Greenhouse Gas Emissions and Fuel Efficiency Standards for Medium- and Heavy-Duty Engines and Vehicles - Phase 2

Response to Comments for Joint Rulemaking

Office of Transportation and Air Quality
U.S. Environmental Protection Agency

National Highway Traffic Safety Administration
U.S. Department of Transportation

Figure 2 Comparison of chassis rolls fuel economy vs Powertrain-in-the-loop fuel economy

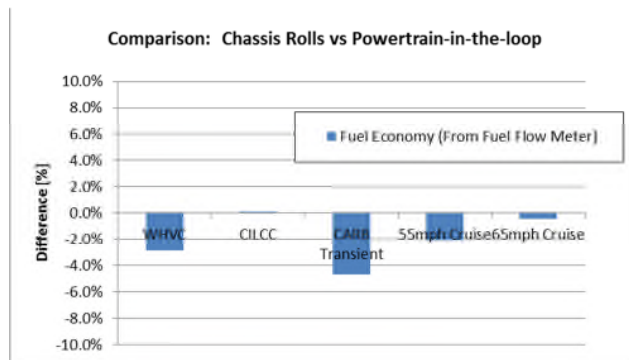
The preliminary results obtained through the powertrain test are uncertain and unproven.

The agencies have modified the powertrain procedure for Phase 2, so that the output of the tests can be used in GEM without A to B testing for a wide range of vehicle configurations. The procedure has been tested and validated with testing at Oakridge National Laboratory (ORNL), Southwest Research Institute (SwRI) and two manufacture laboratories with parent and child ratings of the engine family. This testing has shown that the procedure can be implemented to meet all the requirements of the procedure including the speed regression of the dynamometer. From this testing the agencies have shown that the procedure is repeatable and accurate for measuring the benefits from integrated powertrains. The agencies have also observed that test-to-test variability of measured fuel of the procedure has a coefficient of variation (COV) less than 0.5%, which is at a level seen for engine testing, even though the procedure is testing the transmission with its own variability in addition to the engine. The figure below shows that powertrain testing compares on an absolute basis to chassis testing, but typical COV of chassis testing of heavy-duty vehicles is greater than 2%, due to the additional variability of the driver and the tires.

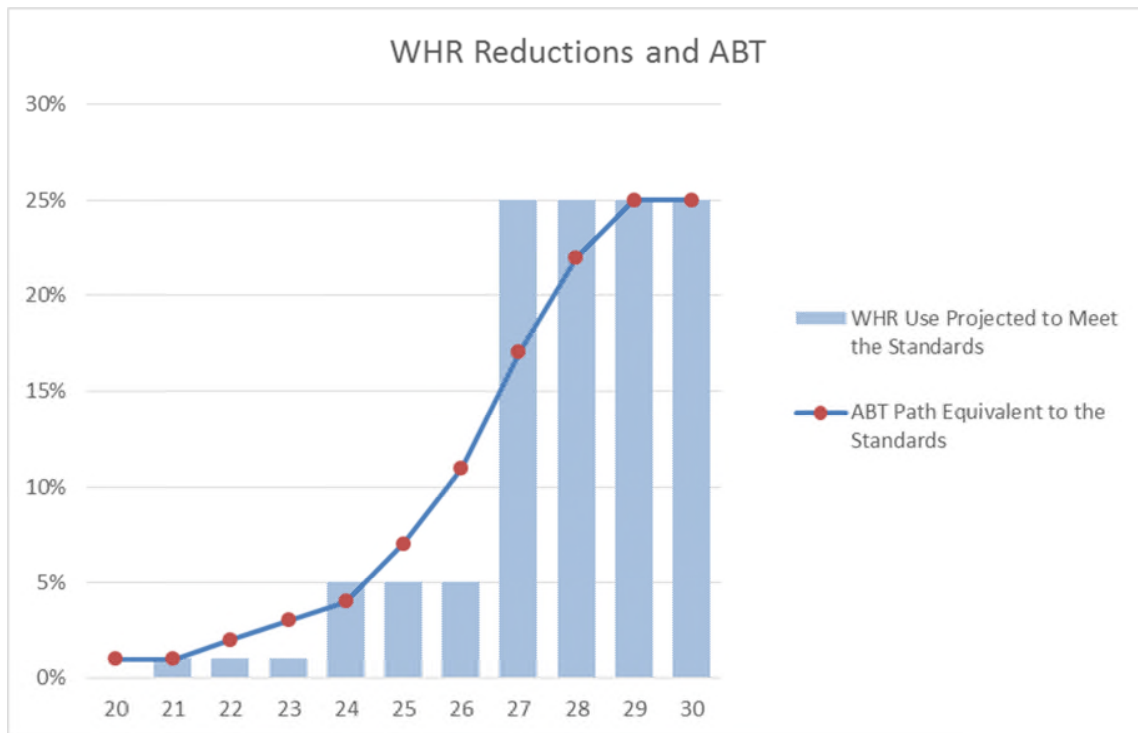
Alternatively, a number of commenters including Cummins, ICCT, CARB, ACEEE, EDF, Honeywell, ARB and others stated that the agencies should increase the assumed application rate of WHR in the final rule and the overall stringency of the engine standards. They argued the agencies' WHR technology assessment was outdated and too conservative, the fuel savings and GHG reduction estimation for WHR were too low, and the agencies' cost estimates were based on older WHR systems where costs were confounded with hybrid component costs and that these have since been improved upon. In addition, the agencies received CBI information supporting the arguments of some of these commenters.

Cummins stated the agencies underestimated the commercial viability of WHR and that we overstated the development challenges and timing in the NPRM. They said WHR can provide a 4 to 5 percent improvement in fuel consumption on tractor drive cycles and that WHR would be commercially viable and available in production as early as 2020 and will exceed the agencies' estimates for market penetration over the period of the rule. According to Cummins, the reliability of their WHR system has

Per-Vehicle Technology Cost Increase for General Motors by Model Year and Alternative (Method A)

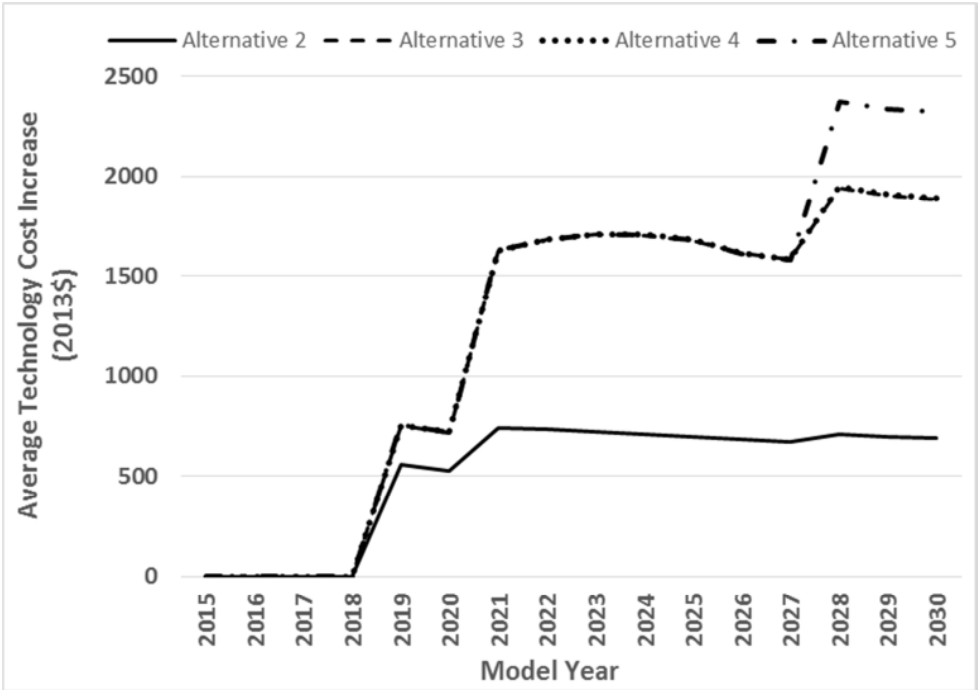
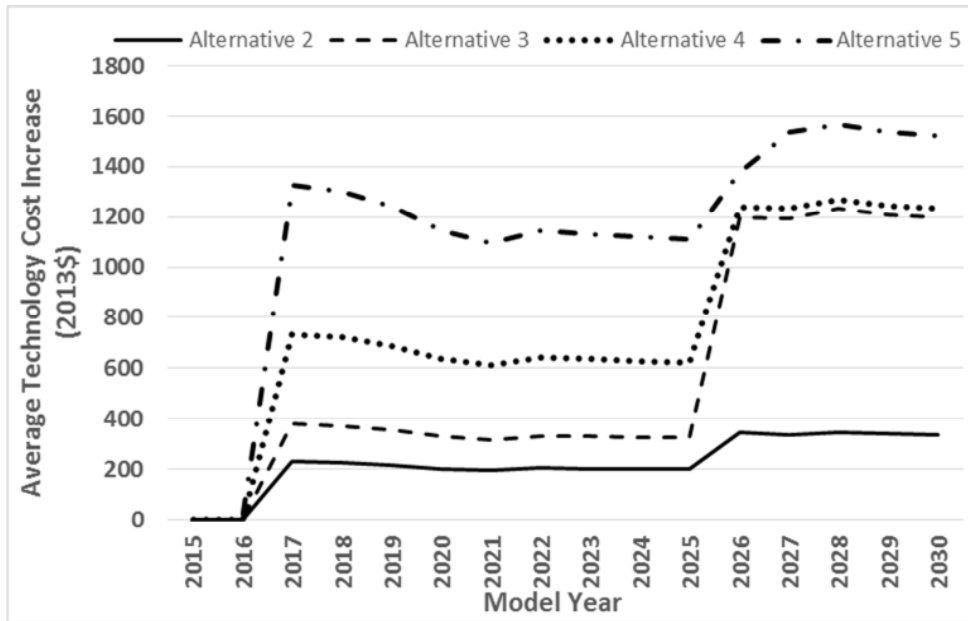
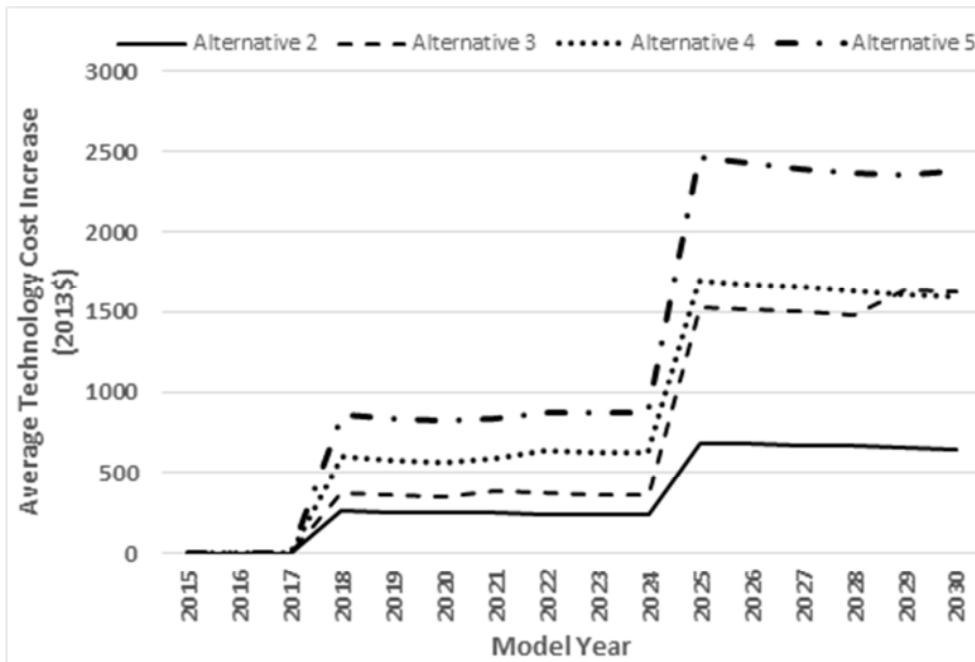
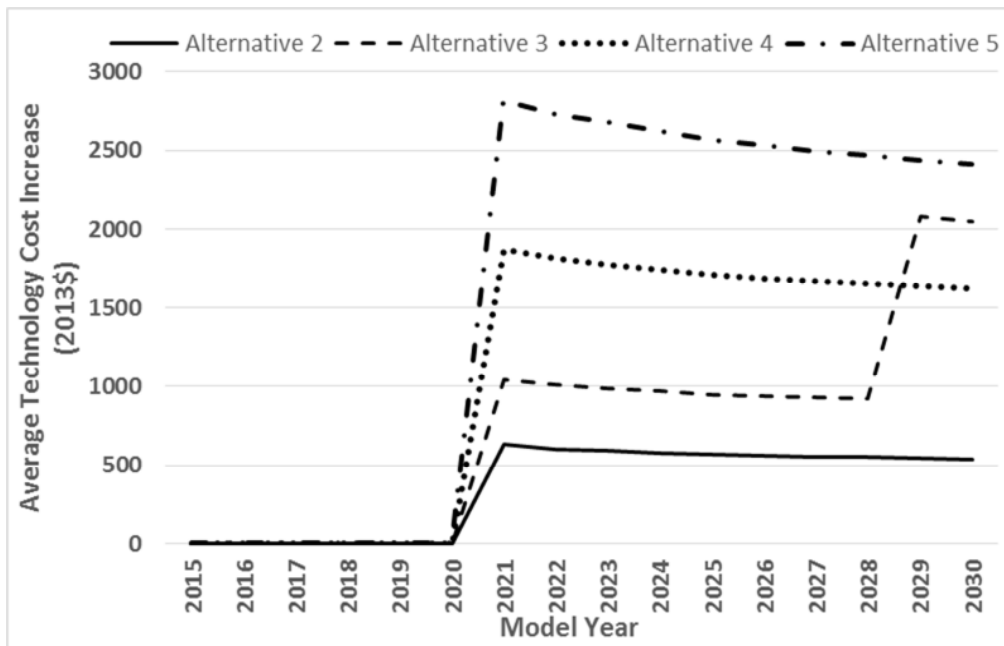
Similarly, FCA shows technology costs of \$300 in MY 2018 under Alternative 3, \$600 under Alternative 4, and \$800 under Alternative 5. Nissan shows costs of \$1000 in MY 2021 under Alternative 3, \$1800 under Alternative 4, and \$2700 under Alternative 5. The only manufacturer not shown here is Daimler; using the 2015 reference fleet Daimler does not apply additional technology in the regulatory alternatives, and incurs no additional costs. The general sequence of simulated technology costs remains the same as in the NPRM and Method B of the FRM; Alternatives 4 and 5 involve more each incurrence of technology costs than Alternative 3, even though the ending stringency curves for Alternatives 3 and 4 are the same, the additional lead time allows that manufacturers could implement technologies on during later redesigns under Alternative 3. While modeling results show that Alternative 3 could involve some early model year technology costs, they also show that Alternative 2 would forgo much of the benefits of Alternative 3. Further, the results shown here represent only one possible way that manufacturers may meet regulatory alternatives; they may avoid adding technologies in early model years, but adding more to reach over-compliance in later model years. For these reasons, NHTSA has determined that Alternative 3 represents the maximum feasible standards. Further description of the rationale behind the finalization of these standards can be found in Chapter VI.D.(9) of the Preamble and Chapter 10.2.8 of the RIA.

The figures below show the year-by-year average per vehicle technology costs for Method A for GM, Ford, Fiat/Chrysler, and Nissan. The simulated GM progression of technology costs is similar under Alternatives 3 and 4. However: Ford, Fiat/Chrysler, and Nissan show more technology costs in early model years under Alternative 4 rather than Alternative 3. Ford’s simulated compliance strategy shows per-vehicle technology costs of \$400 in MY 2017 under Alternative 3, \$700 under Alternative 4, and almost \$1400 under alternative 5. Alternatives 4 and 5 would put the majority of the cost burden on the

MY 2017 redesign, while Alternative 3 allows most of the cost burden to be on the MY 2025 redesign. The MY 2017 fleet will be in production at the time of publishing this rule. The next major redesign for Ford is not until MY 2025; to add an additional redesign in between the MY 2017 and MY 2025 fleet would involve much capital investment and does not seem feasible.

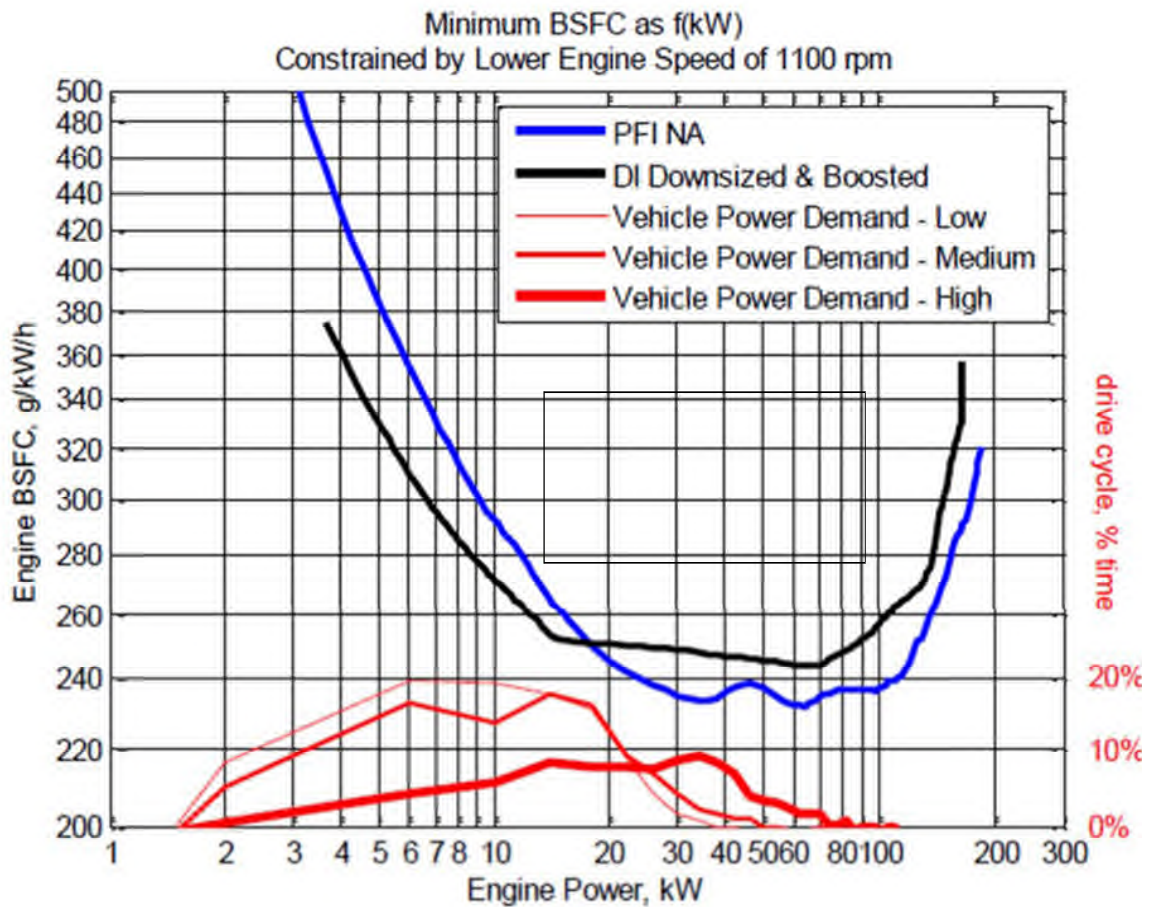
AAPC commented in support of an alternative year-over-year phase-in that would phase-in stringency more gradually than the proposed (and now adopted) standard. AAPC recommended that rather than a 2.5 percent per year improvement, the increase should be at 1.75 percent per year through MY 2024 and then 3.5 percent per year for MY 2025 through 2027 with the MY 2027 level of stringency equally the proposed level. AAPC commented that this more gradual approach was consistent with the Phase 1 phase-in approach and would help manufacturers manage the long lead time associated with developing the new vehicles and powertrains that will be required in order to comply with the Phase 2 proposal.

The agencies are finalizing the proposed phase-in rather than adopting the approach recommended by AAPC. The more gradual phase-in recommended by AAPC would result in a loss of program benefits in each of the interim years of the program compared to the promulgated standards until the phase-in caught up with that phase-in in MY 2027. Because of the slower phase-in, the overall reduction in each interim year is lower than the phase-in being finalized. The phase-in adopted for Phase 1 with a more gradual ramp-up in standards took into consideration the shorter lead time associated with the Phase 1 standards and the uncertainty associated with implementing a new program. Phase 2 provides more lead-time than Phase 1 and the agencies believe based on their analyses of the standards that the lead-time provided is sufficient, particularly considering the flexibility also provided by credit carry-forward and carry-back provisions.
